JONES
ASSOCIATES
Foresters, Surveyors and
Environmental Consultants

March 7th, 2023

On behalf of Auburn Suburban Baseball and Softball, Jones Associates, Inc. is pleased to submit information regarding their Development Review Application for their proposed project located at Stevens Mill and Hotel Road in Auburn, Maine. This information is being submitted by request of the Planning, Permitting, and Code Department, as outlined in an email sent on February 21st, 2023, and during a remote meeting held on February 27th, 2023.

PROJECT NAME: SITE PLAN
AUBURN SUBURBAN
BASEBALL & SOFTBALL
STEVENS MILL ROAD
AUBURN, MAINE

SHEET: S-1
PLAN DATE: FEBRUARY 8, 2023
SCALE: 1"=60'
PROJ. #:21-011AU

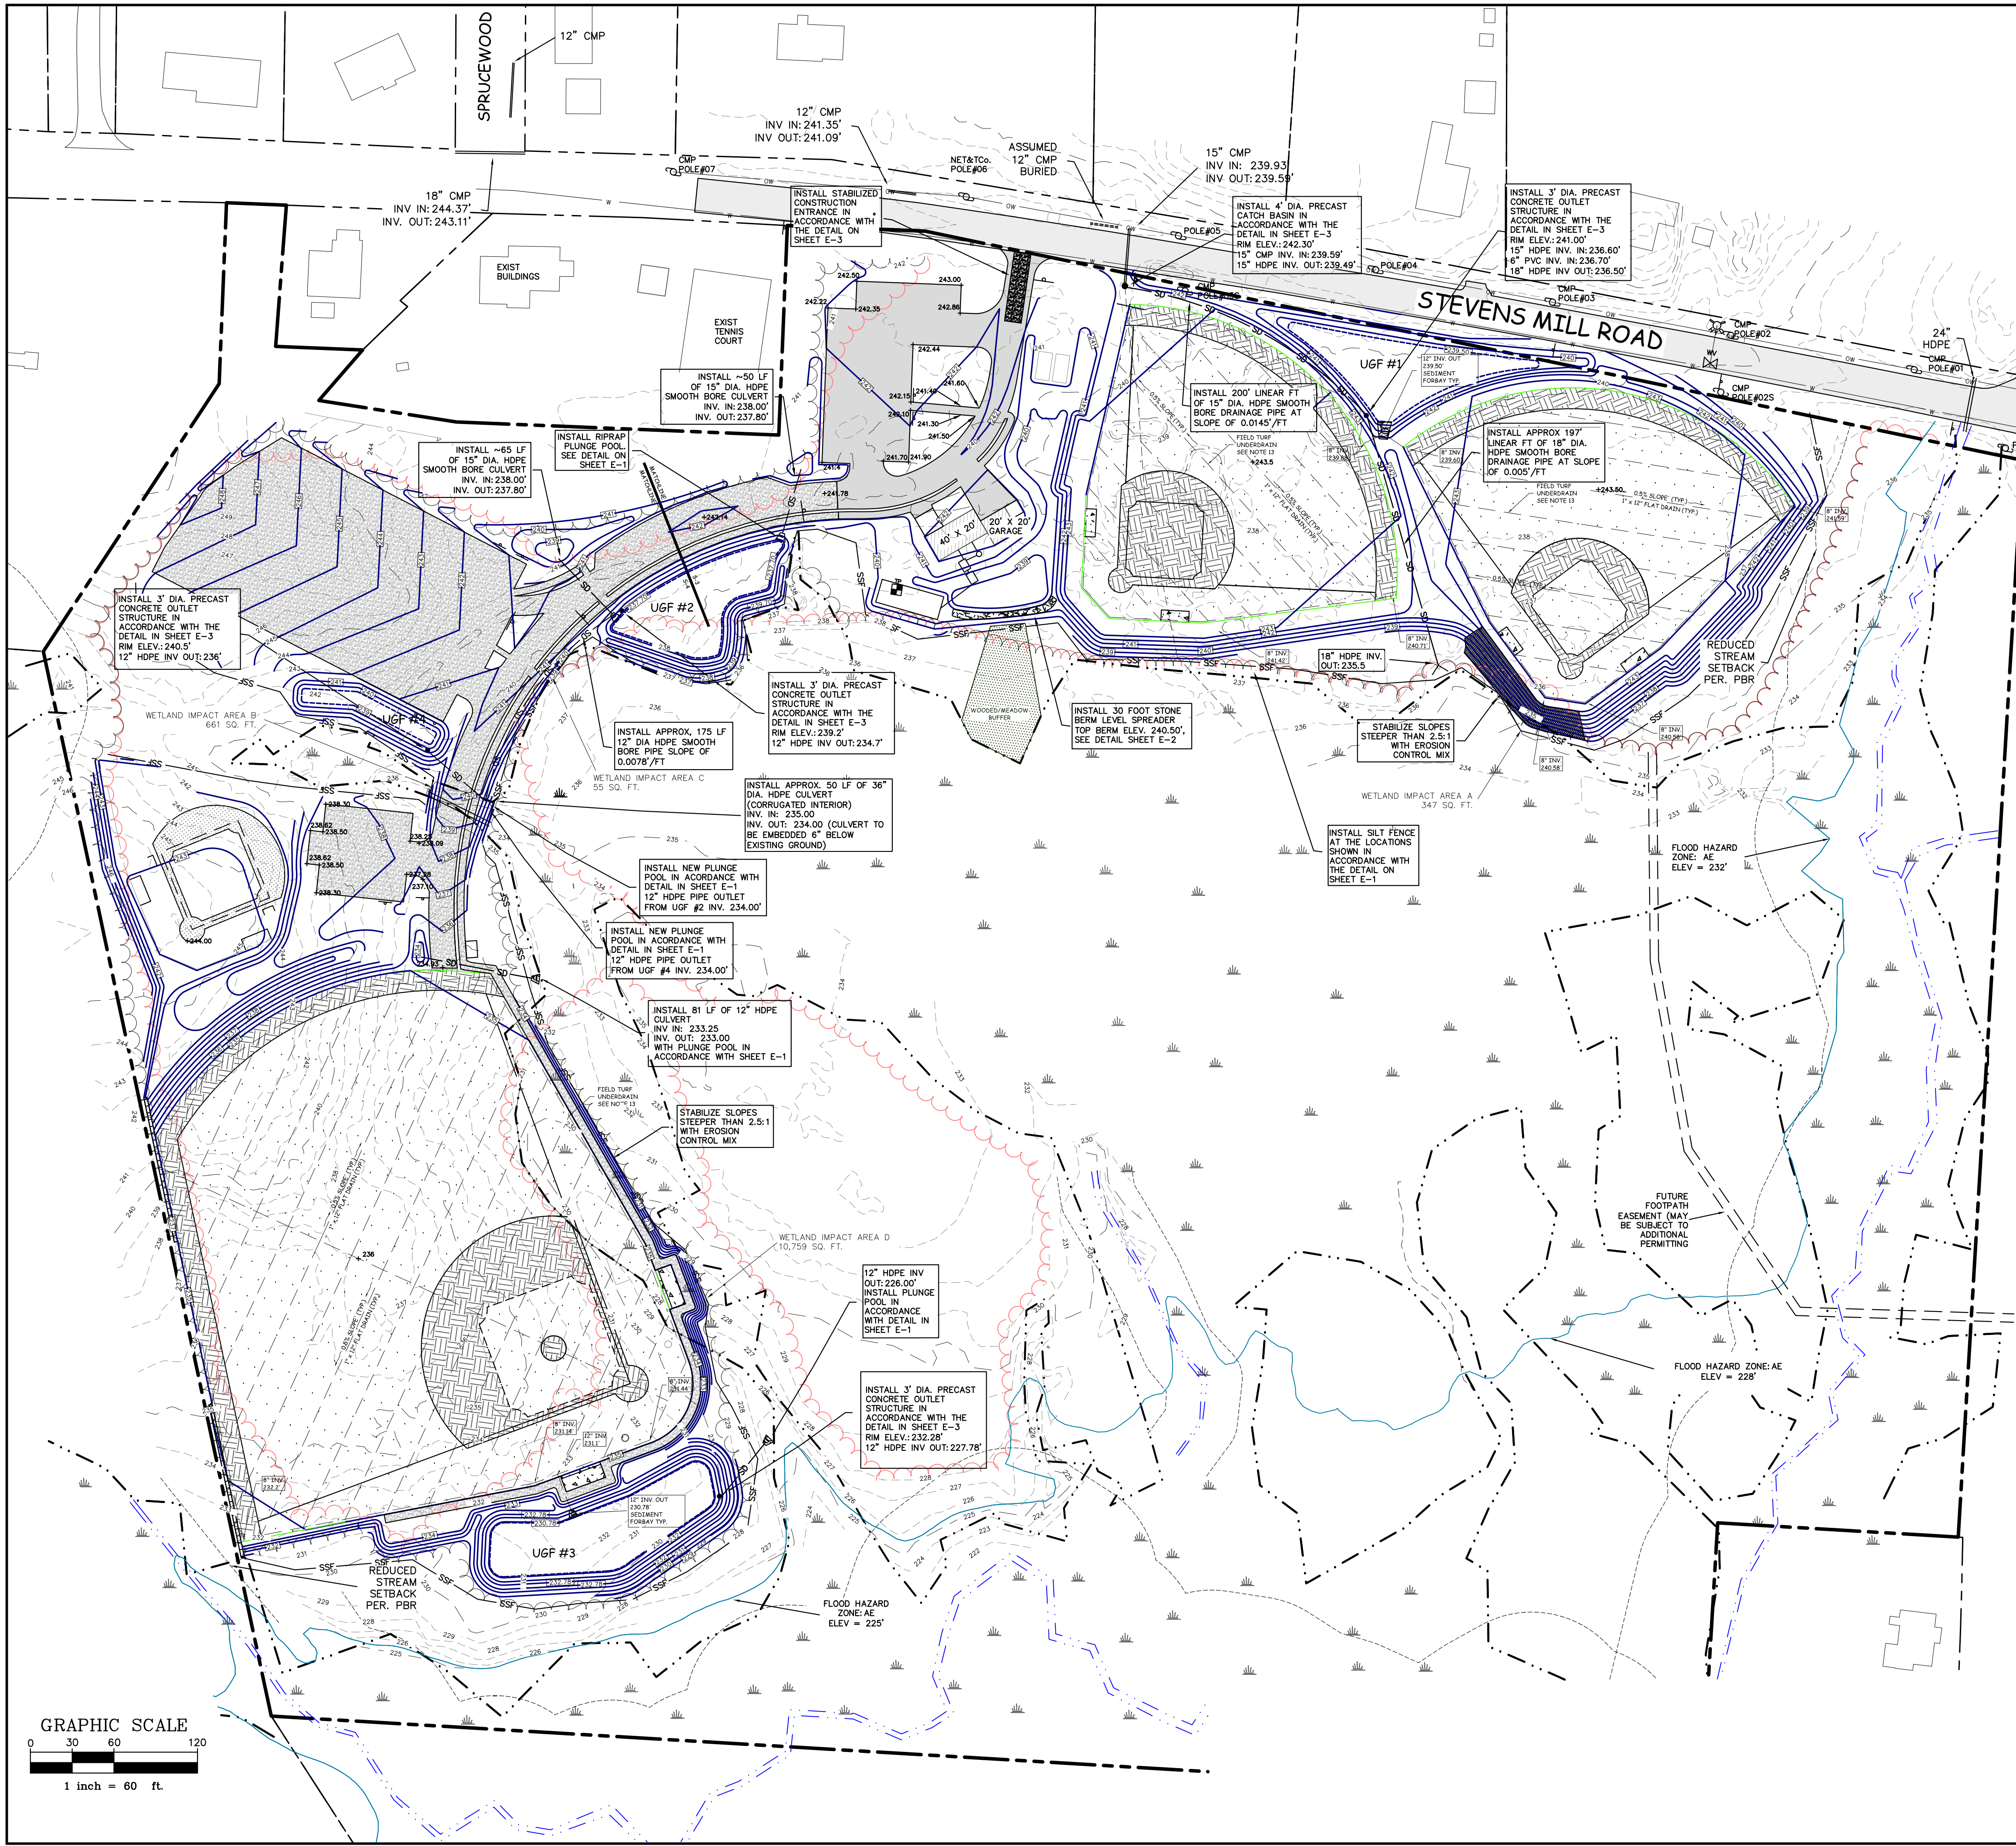
Details regarding no parking signs are now shown along Stevens Mill Road to Garfield Road. The shoulder of Stevens Mill Road has also been widened by approximately 10 feet, specifically between the road and under drained soil filter (UGF) #1, which is located between the two little league fields. A crash gate between Stevens Mill Road and the easternmost little league field has also been added to the plans.

The location of a future footpath has been added to the plans, connecting the easternmost little league field to Hotel Road. This future footpath may be subject to additional permitting.

Notes on site distance have been adjusted to reflect site distance for a 45 miles per hour (mph) zone. The site distance was remeasured by Bill Bray of Barton & Loguidice on March 3rd, 2023.

REVISIONS	DATE	DESCRIPTION	BY
1	2/9/23	REVISED PARKING D LOCATION	EJ
2	3/2/23	REV. SIGHT DISTANCE, ROAD WIDTH, NO. PARKING SIGNS AND FUTURE FOOT PATH	EJ

SHEET:
S-2

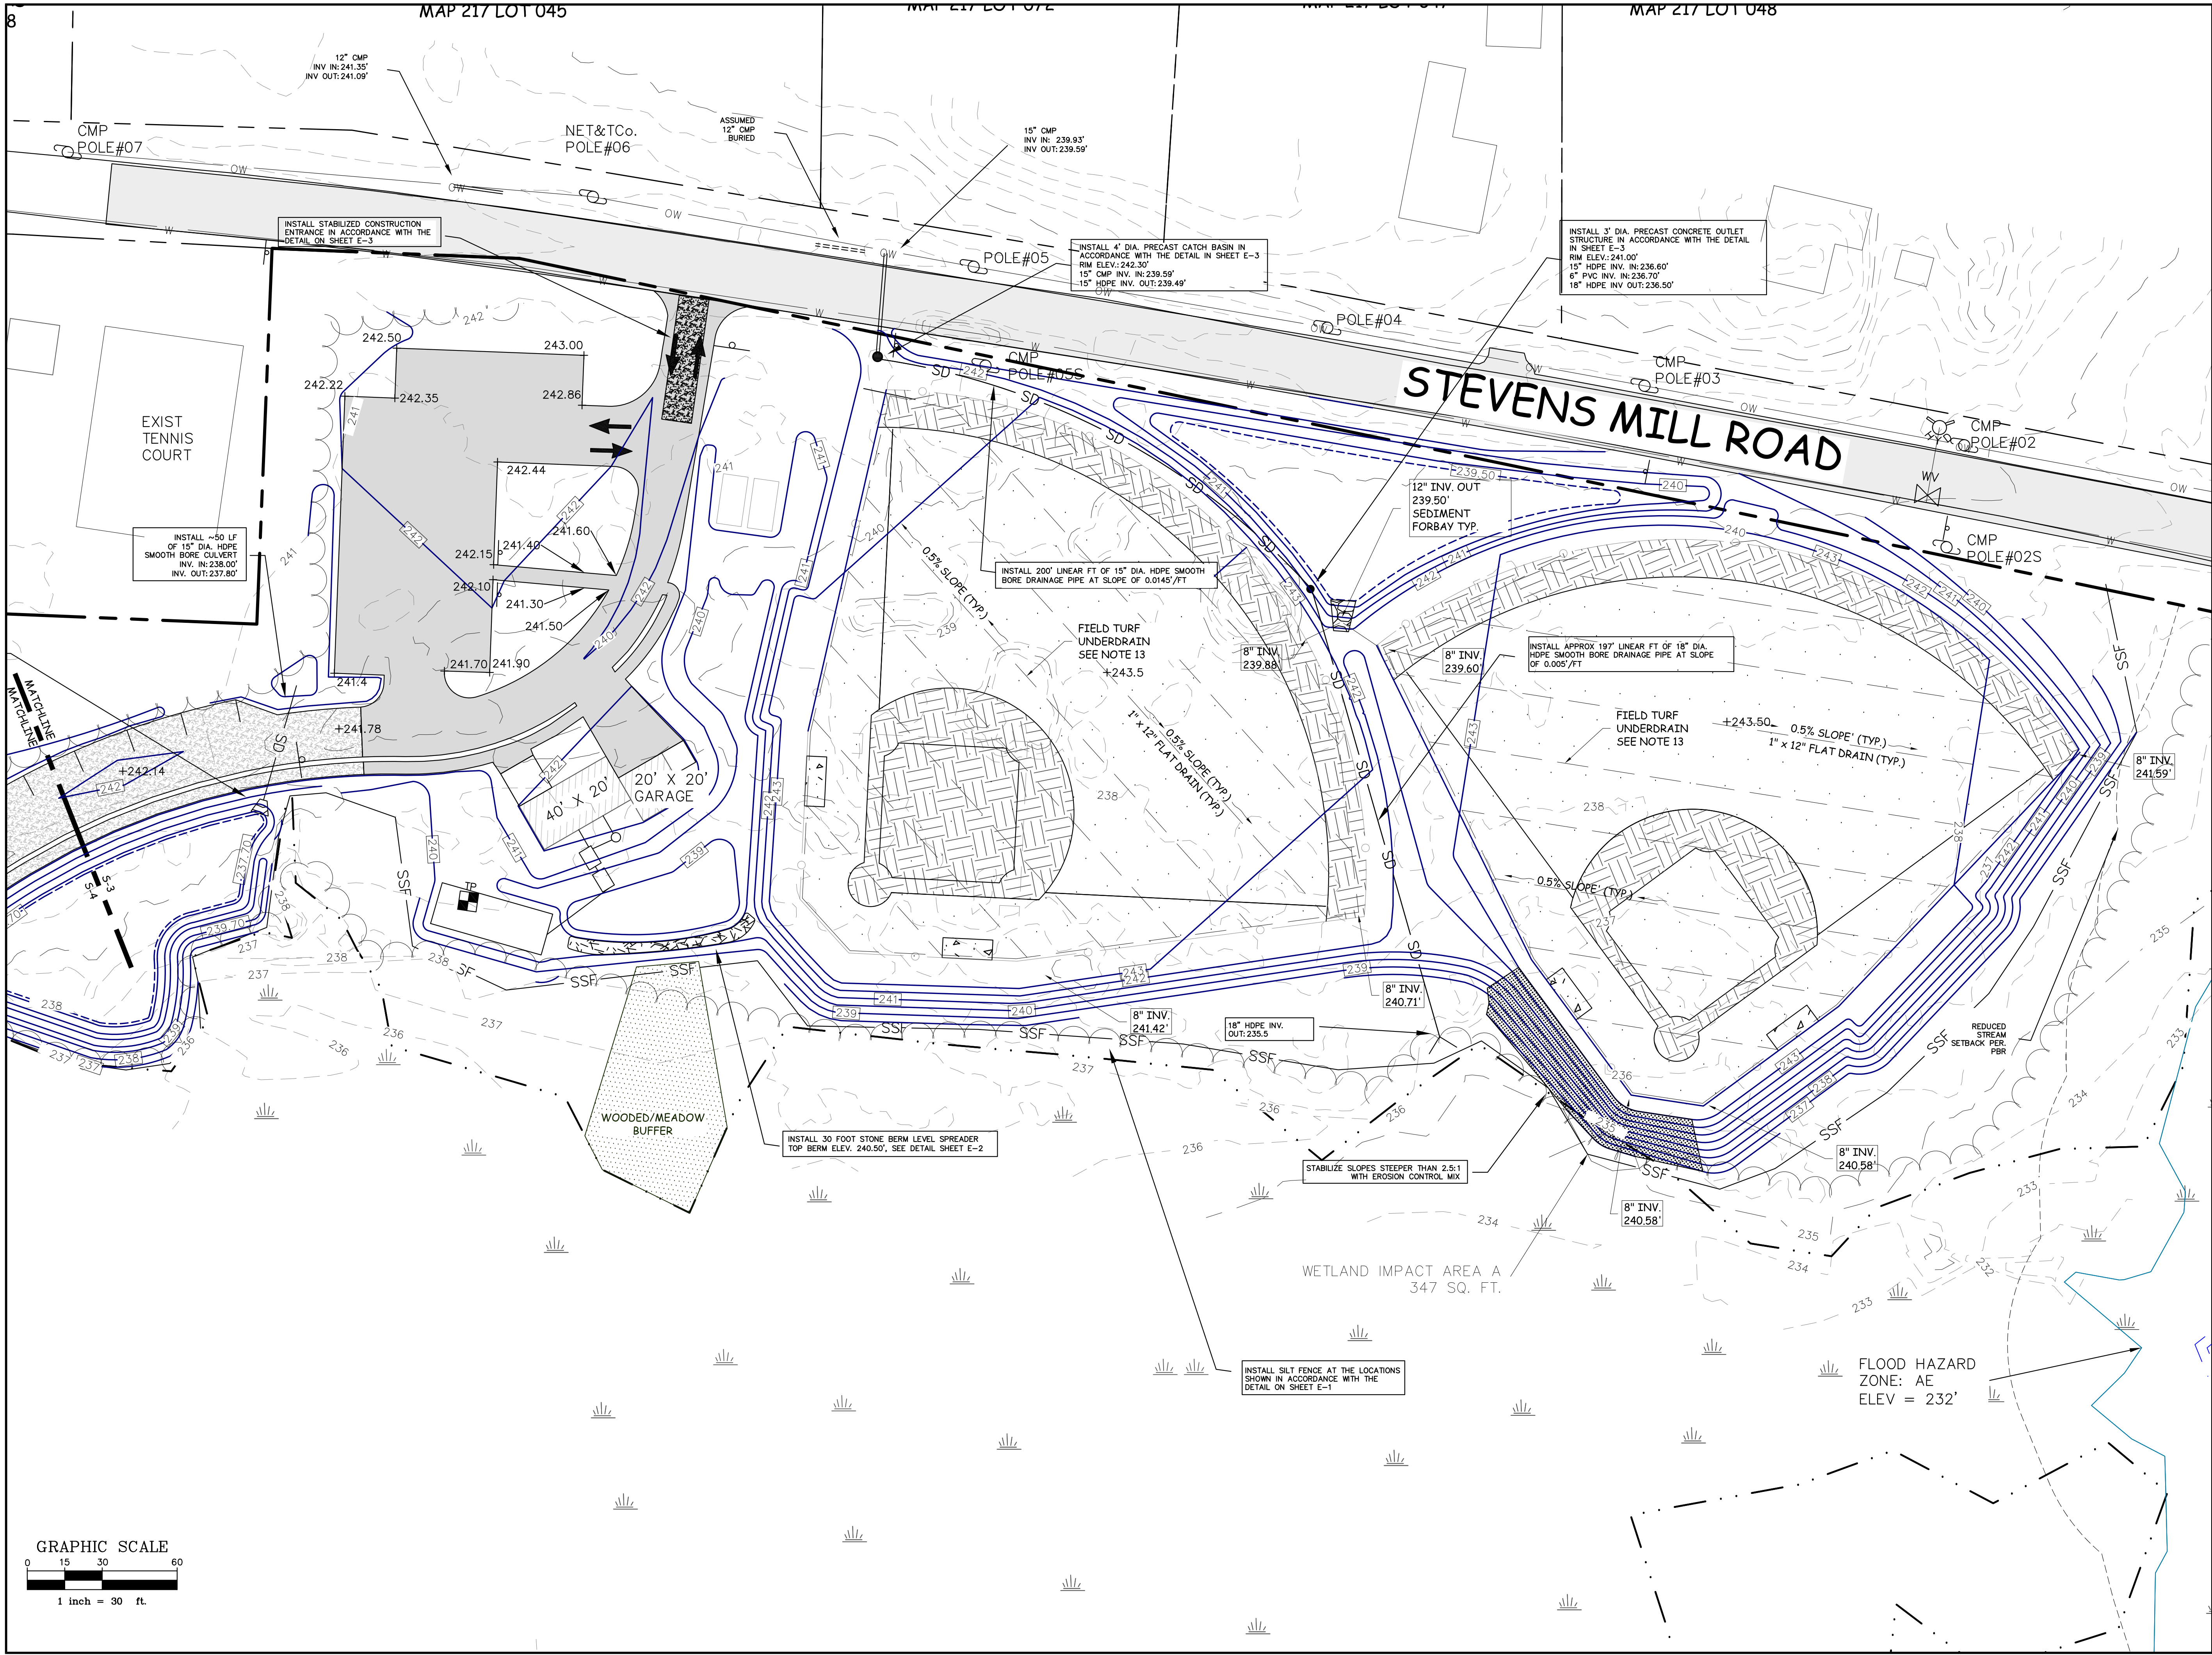
The access road throughout the site has been widened from 18' to 20'. This increase in impervious area required UGF #2 and #4 to be expanded. The revised stormwater report and plans have been updated accordingly and attached to this letter.

REVISIONS	DATE	DESCRIPTION	BY
1	2/9/23	REVISED PARKING D LOCATION	EJ
2	3/2/23	REV. SIGHT DISTANCE, ROAD WIDTH NO. PARKING SIGNS AND FUTURE FOOT PATH	EJ
